PLAN REVIEW SHEET

Petition:

2015-089

Charlotte Parker & Marion McGaha

Bus Stop Waiting Pad Detail

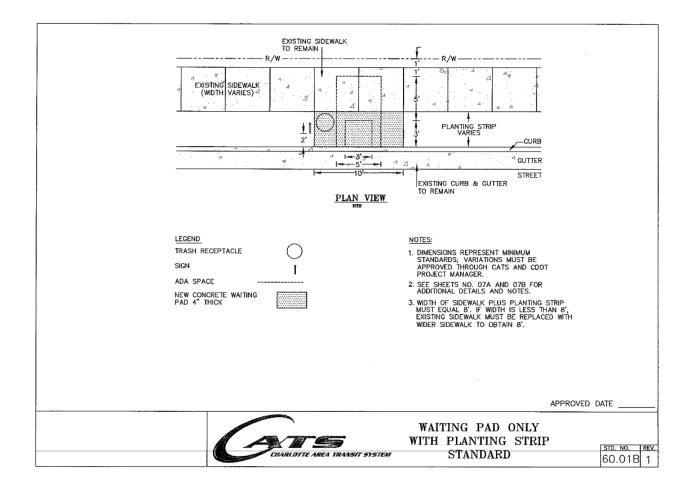
The Petitioner is requested to provide and construct a concrete pad for the existing bus stop on East 36th Street. Below is an image of the standard detail (60.01B) for the requested concrete pad. The site plan may either show the conceptual location of the improved bus stop, or alternatively, include a development note to locate the bus stop pad during the urban review process.
